**COMMUNITY DEVELOPMENT
AND PUBLIC WORKS
ACCESSIBILITY SURVEY**

July, 2007

**CITY OF SANTA
BARBARA**

Public Right-of-Way - Photo # 5

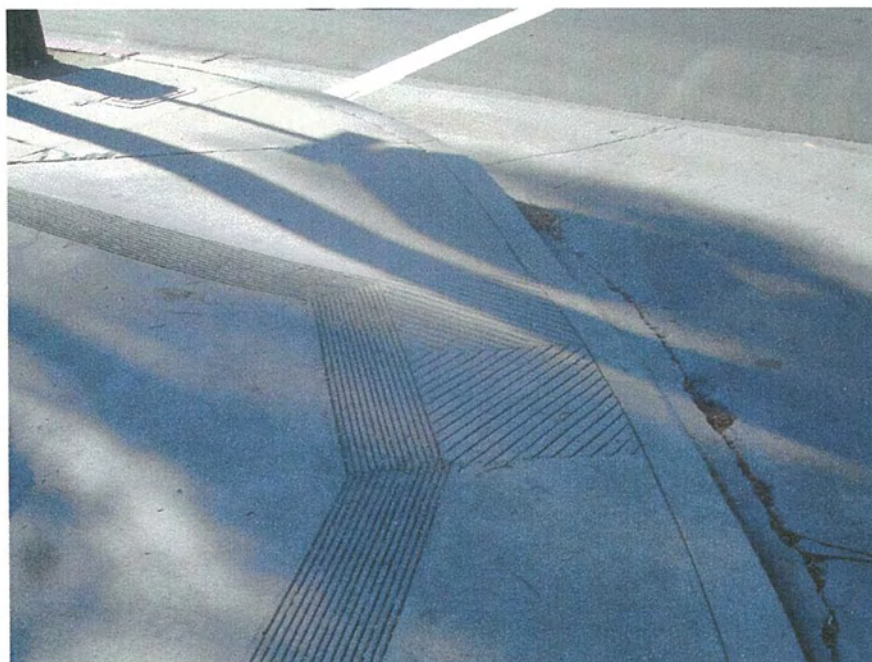
Tile sidewalk has excessive cross slope ranging from 3.0% to 4.5% instead of the required maximum 2%.

9 Sidewalk - Main Garden Entrance									\$18,760	
Walks and Sidewalks										
Cross slope.	<2%, (2.5% not to exceed 20')	Cross slope at tile sidewalk, ranges from 3.0% to 3.9%. Photo #: 5	ADAAG: 4.3.7 T24: 1133B.7.1.3	Modify walk/sidewalk/pedestrian way to provide compliant cross slope.	670 SF	\$28	\$18,760	3		
10 Sidewalk									\$2,016	
Walks and Sidewalks										
Cross slope.	<2%, (2.5% not to exceed 20')	Cross slope at tile sidewalk, ranges from 2.4% to 3.0%.	ADAAG: 4.3.7 T24: 1133B.7.1.3	Modify walk/sidewalk/pedestrian way to provide compliant cross slope.	72 SF	\$28	\$2,016	3

Site - Photo # 3

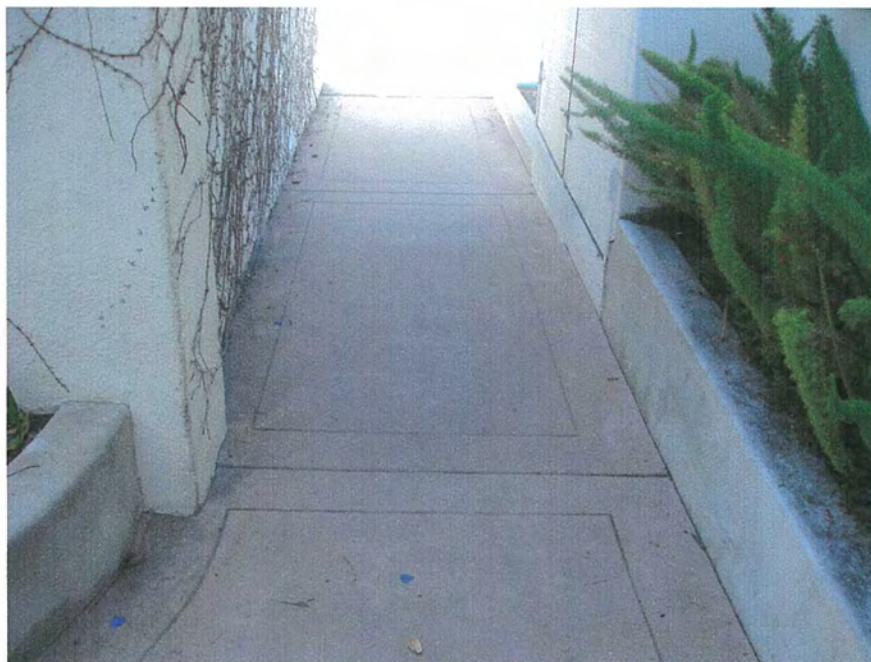
Picnic tables do not have the required knee clearance for wheelchair users.

Site - Photo # 8

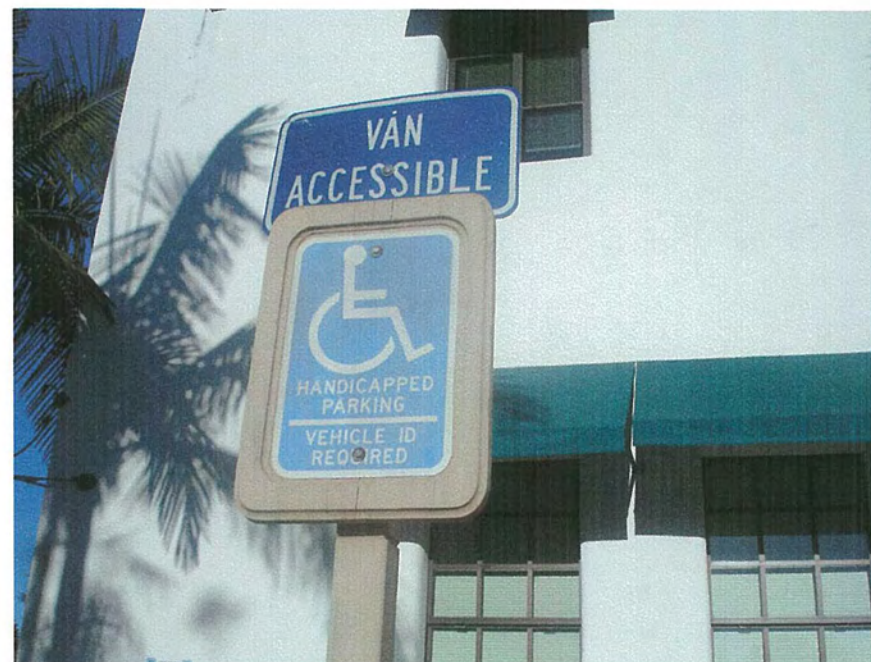
There is no contrasting color with adjacent surfaces. There are no detectable warnings to warn blind pedestrians that they are going into a vehicular area. A van sign should be added to the parking sign since this is the only accessible stall at staff parking.

Building - Photo # 2

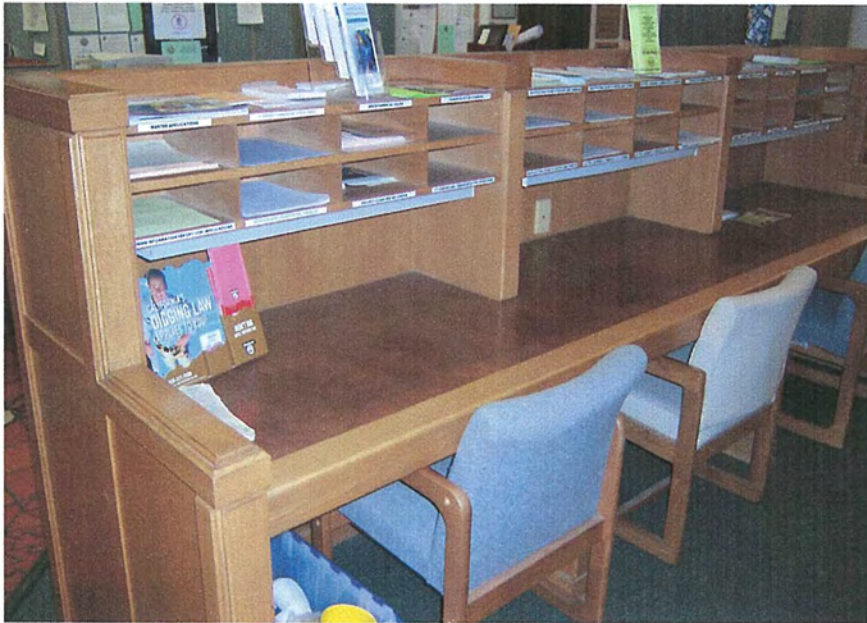
Counter mounted too high - 42" high, without a low section for wheelchair users at 34" high maximum.

Building - Photo # 4

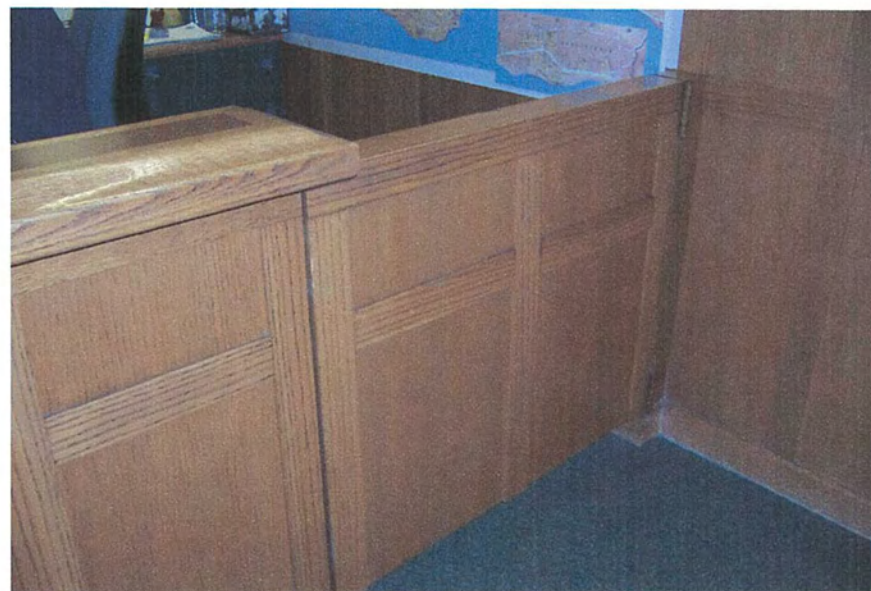
Counter mounted too high - 42" high, without a low section for wheelchair users at 34" high maximum.

Building - Photo # 8

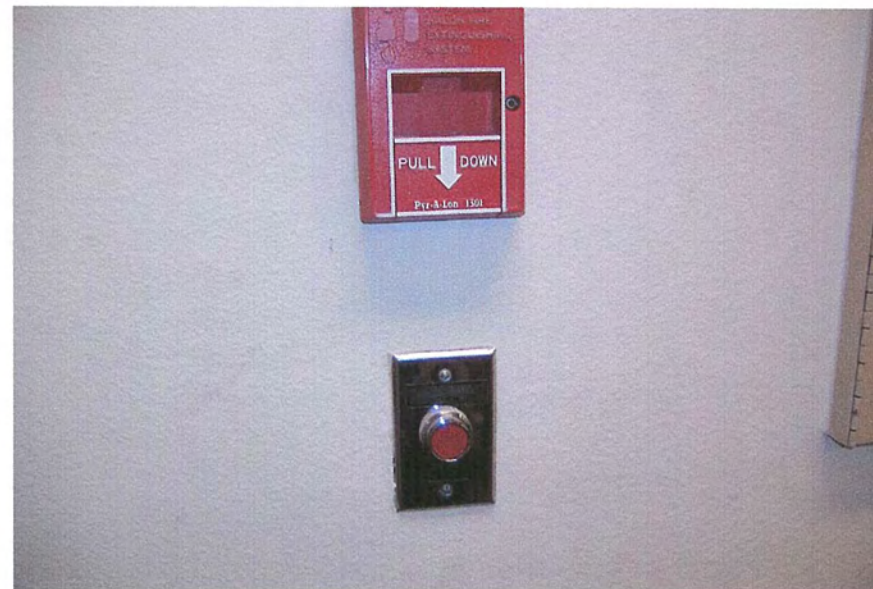
File cabinet blocks the required 60" maneuverable clearance in front of doors - 39" provided.

Building - Photo # 11

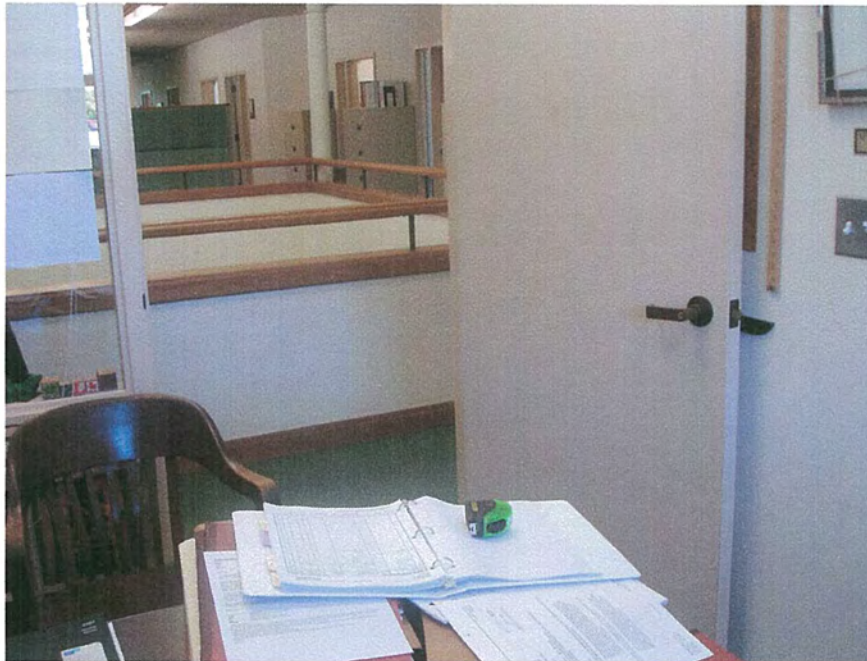
Coat hook mounted too high, there is no “U-pull” at both side of compartment door. Door not self-closing and clear opening 33” wide instead of 34” at a side entry stall with in-swinging door.
